Rush Creek Hydroelectric Project (FERC Project No. 1389)

VOLUME III (PART 2 OF 3): EXHIBIT E SUPPORTING DOCUMENT A DRAFT TECHNICAL STUDY REPORTS

Table SD A-2. Stakeholder Comments on Draft Technical Study Reports and Associated SCE Responses

INYO National Forest Comments on DEC 1 Full Decommissioning Study Phase 1, Rush Creek Hydroelectric Project No. 1389

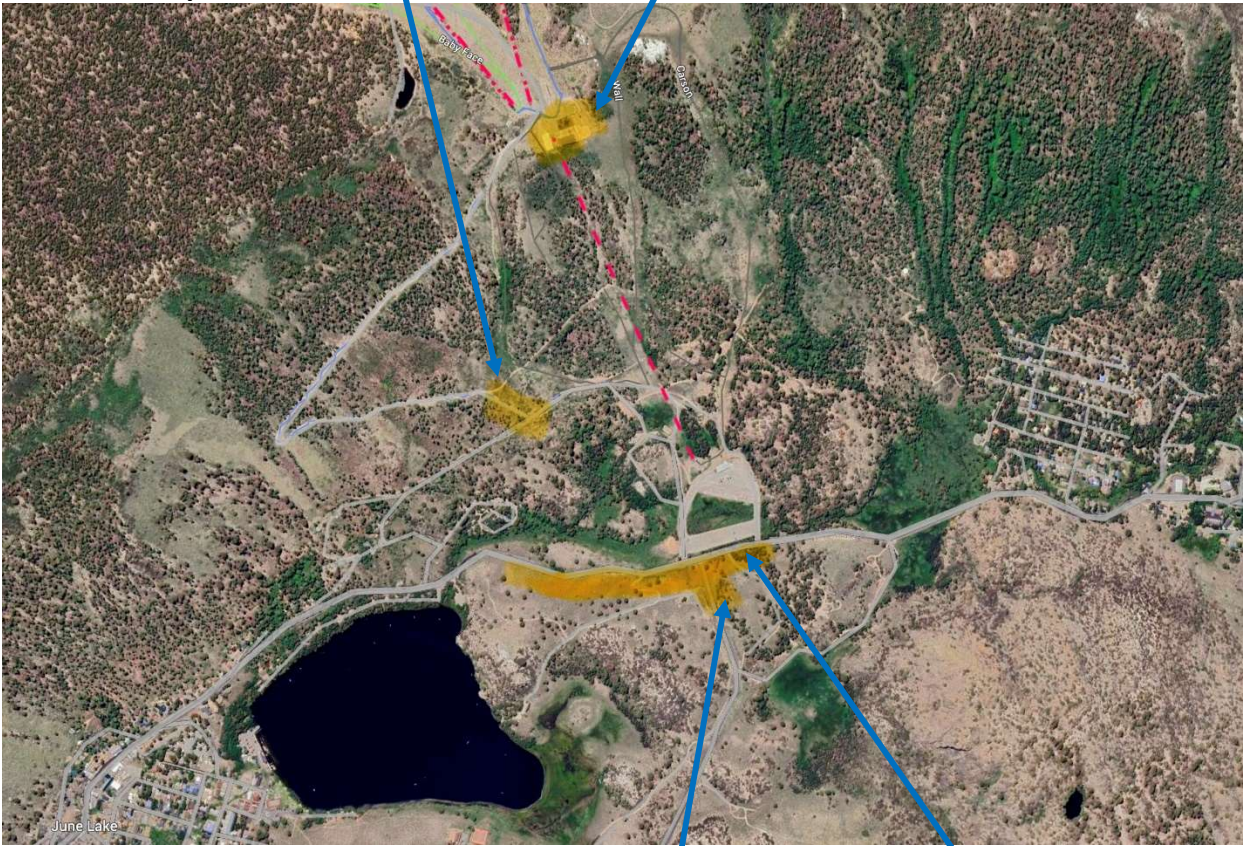
The four KOP locations recommended by Mono County for the expanded study simulations include:

- (1) June Lake Loop Trail
- (2) Mid-Chalet on June Mountain (where events are held and scenic chairlift rides terminate)
- (3) Scenic Highway 158 (viewing west on approach to the ski area parking lot)
- (4) North Shore Drive (where it approaches from the Rodeo Grounds property).

A map is provided on the following page to show the general vicinity of these recommended KOP locations. Each of the identified sites will require field verification to determine the most representative viewpoint.

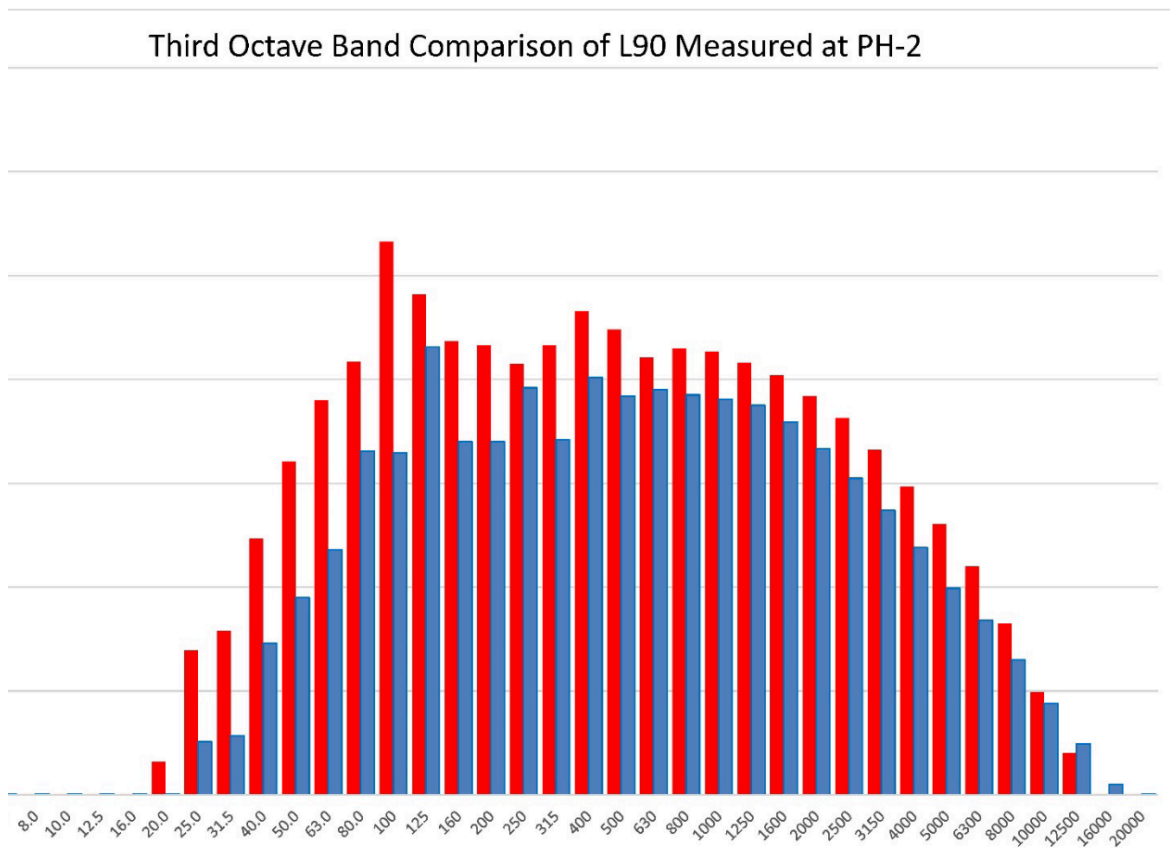
In the graph above, an indistinct noise peak can be seen in the range of 100Hz.

Due to the limited spectral resolution in the above graph, it is impossible to discern that this is clearly a tonal noise.

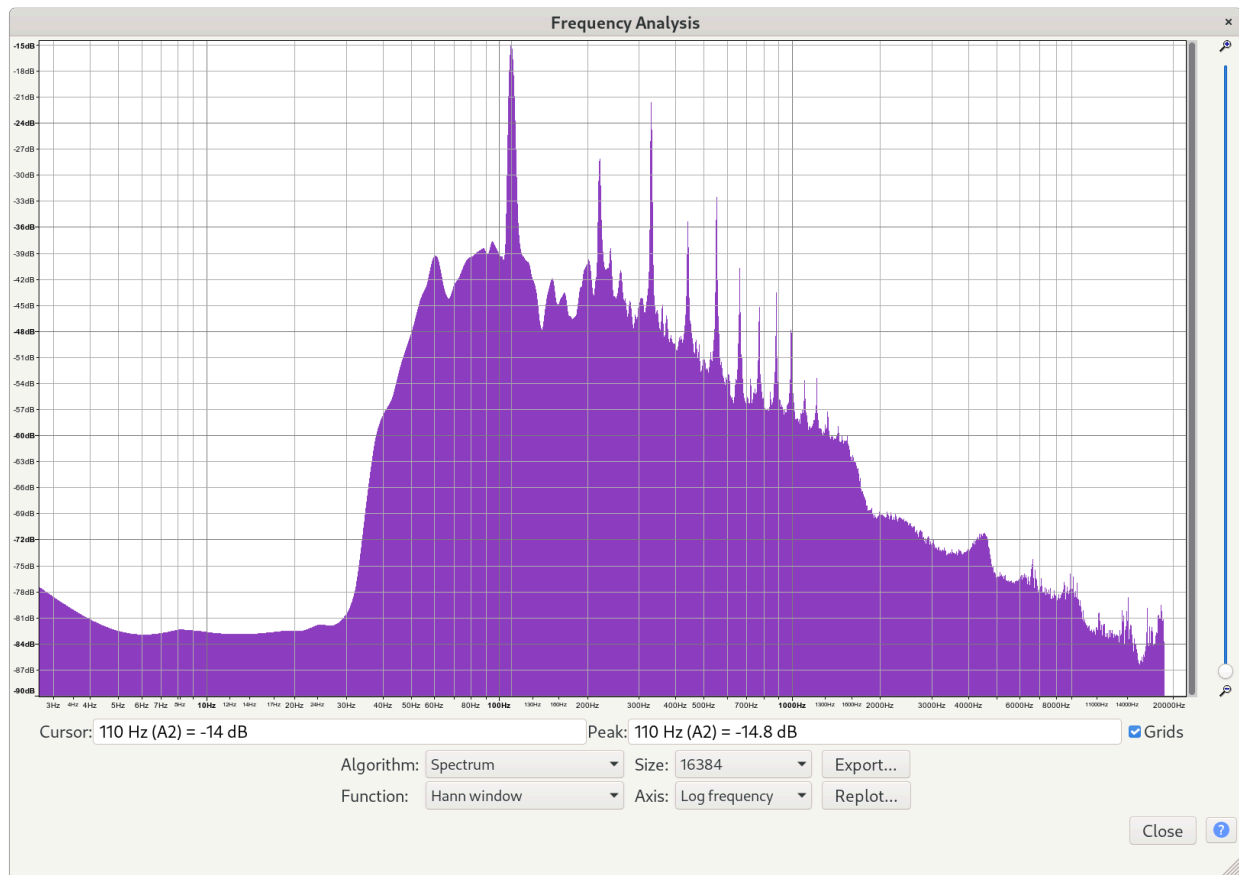
Below is a chart based on recordings that I made at a previous time from a location on Highway 158 close to the powerhouse tailrace:

This chart, presented at much higher spectral resolution shows clear tonal noise at the same frequency of approximately 100Hz, which is **25dB larger in magnitude than the pink background noise**. There are also numerous tones present at other frequencies which barely present at all in the graph included in the study report.
